SUBURBAN COLLECTION SHOWPLACE EXPANSION JSP16-12

Public Hearing at the request of TBON, LLC for Planning Commission's recommendation to City Council for approval of Preliminary Site Plan, Wetlands Permit and Stormwater Management Plan. The request is for an expansion of the building and parking lot for land within the OST, Planned Office Service Technology District, and in the OST, Planned Office Service Technology District with an EXO, Exposition Overlay District. The subject property is located in section 16, north of Grand River Avenue and west of Taft Road. The applicant is proposing to expand the existing showplace exposition facility by adding a 172,315 square foot building addition, with associated parking lot and other site improvements. The current revised plan proposes changes to the previously approved building elevations, adding more parking spaces, and corresponding site improvements.

PLAN REVIEW CENTER REPORT

To	Barbara McBeth, AICP	Page	1
CC	Sri Komaragiri		
Subject	JSP 16-0012 – Suburban Collection – Revised Final – Traffic Review		
From	Matt Klawon, PE Maureen Peters, PE		
Date	December 14, 2016

PREVIOUSLY APPROVED LAYOUT

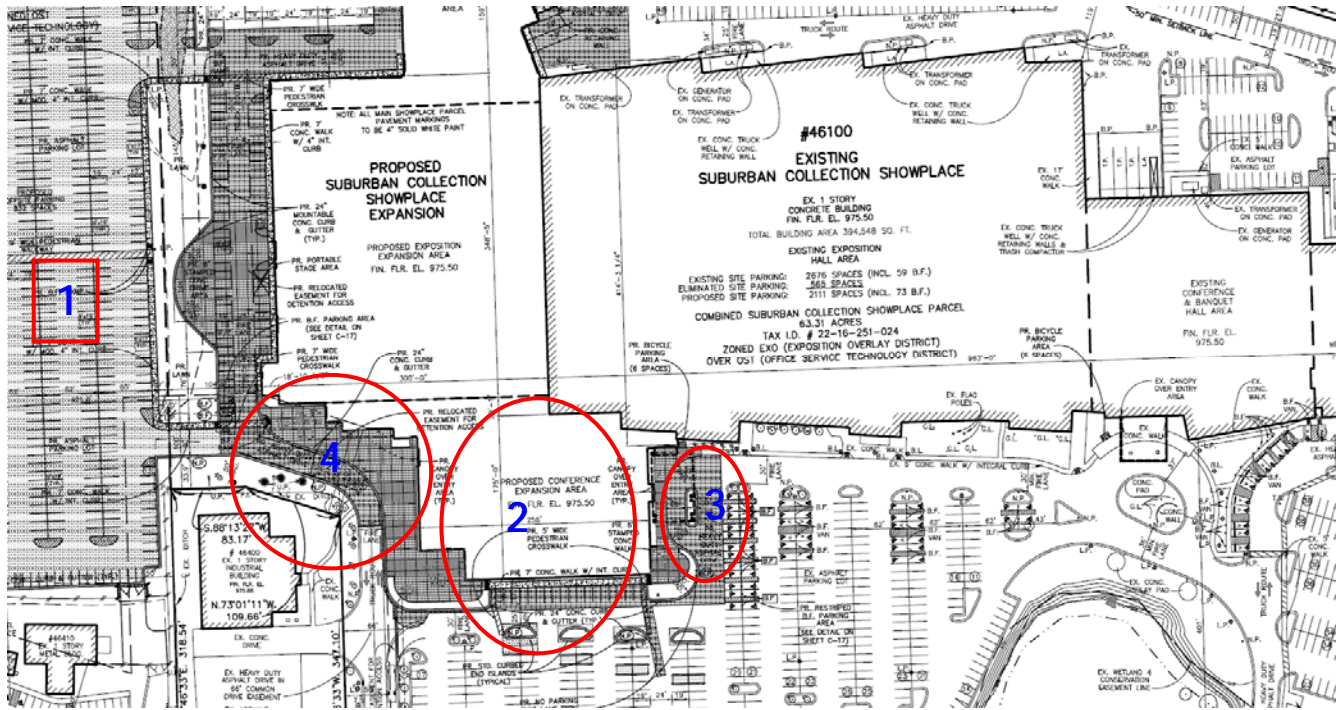
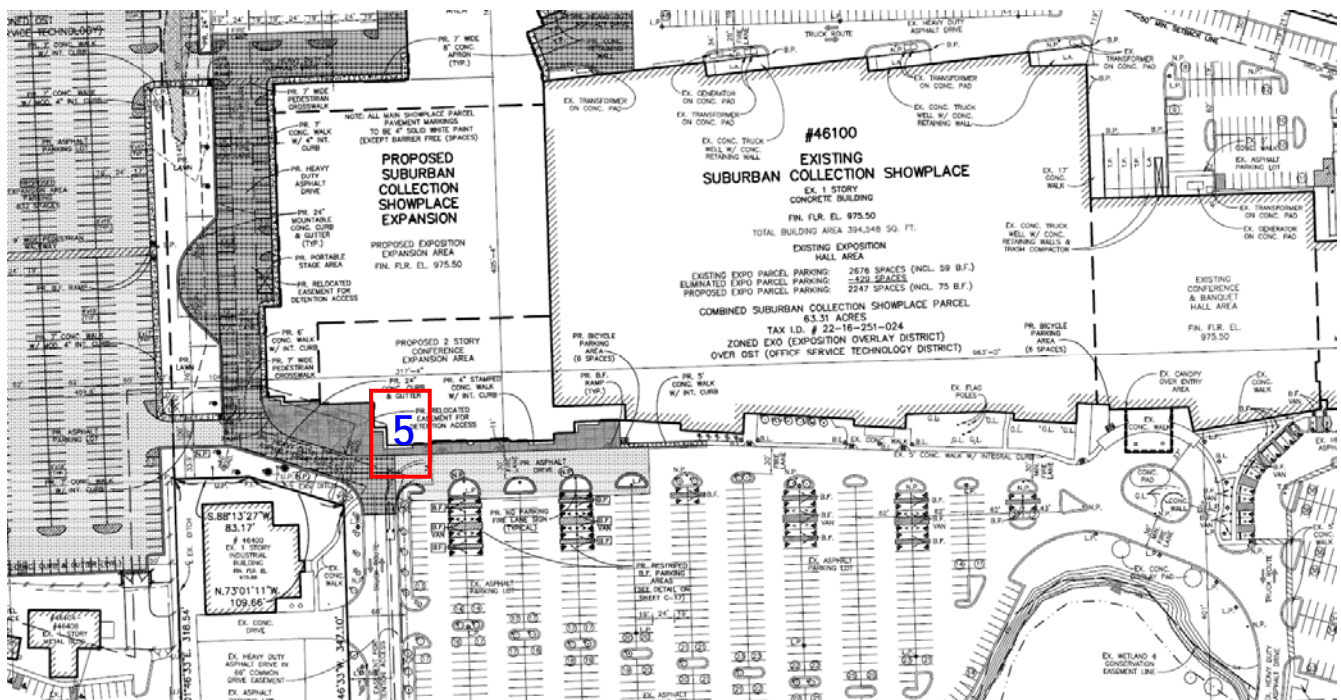
The applicant received final stamping set approval on **October 20, 2016**. The applicant is now requesting to approve the revised site plan. The following changes have been made from previously approved site plan.

2. Building footprint: The building projection from the approved plan is now replaced with additional parking spaces. Building façade line in the current plan aligns with the existing façade line.

3. Drop-off Area: The drop-off area to the east of the previously approved building footprint is now replaced with additional parking spaces.
4. Outside Patio Area: Due to change in building footprint design and addition of parking spaces, the amount of outside patio area in the south west corner of proposed addition, similar to those found near the Hyatt Hotel on the east side of the site, has been reduced considerably.

Figure 1. City of Novi Regulated Wetland & Woodland Map (approximate project location shown in red). Regulated Woodland areas are shown in green and regulated Wetland areas are shown in blue). Approximate overall project boundary is indicated in red.

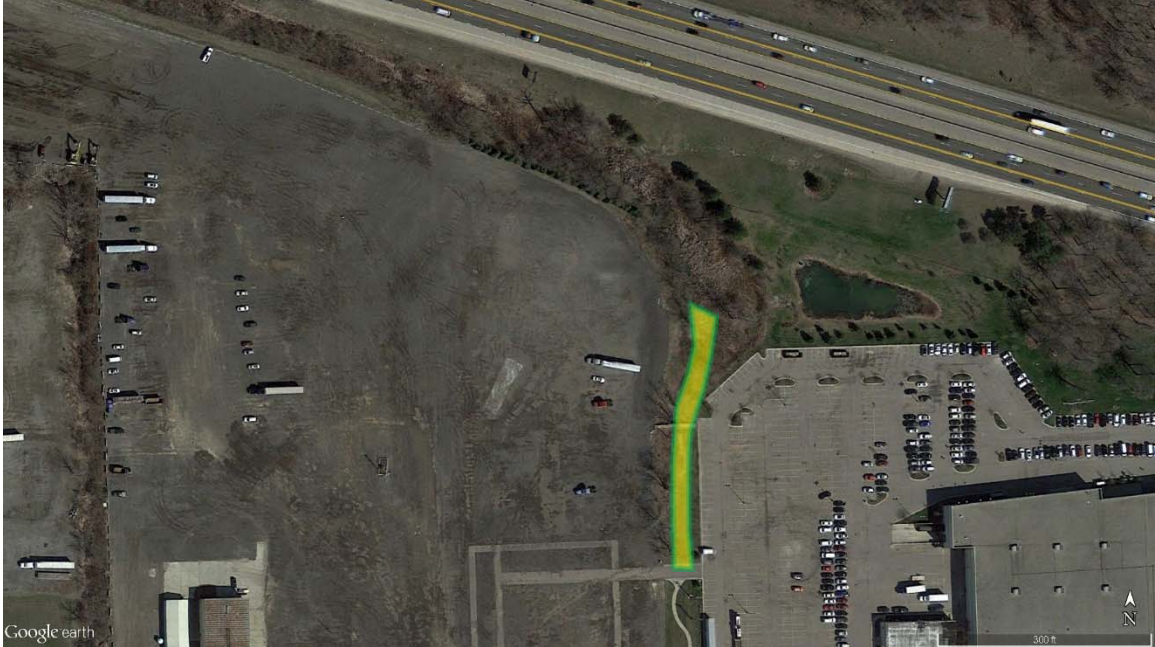
Based on our review of the application, Novi aerial photos, Novi GIS, the City of Novi Official Wetlands and Woodlands Maps (see Figure 1, attached) it appears as if this proposed project site is adjacent to City-Regulated Woodlands and contains City-Regulated Wetland areas.

ECT visited the site on April 22, 2015 as well as on July 6, 2016 for the purpose of a wetland boundary verification. The focus of the inspection was to review site conditions in order to determine whether on-site wetland is considered regulated under the City of Novi's Wetland and Watercourse Protection Ordinance. ECT reviewed the wetland area (Wetland 7/C) at the proposed project location. The approximate project boundary is depicted in Figure 1.
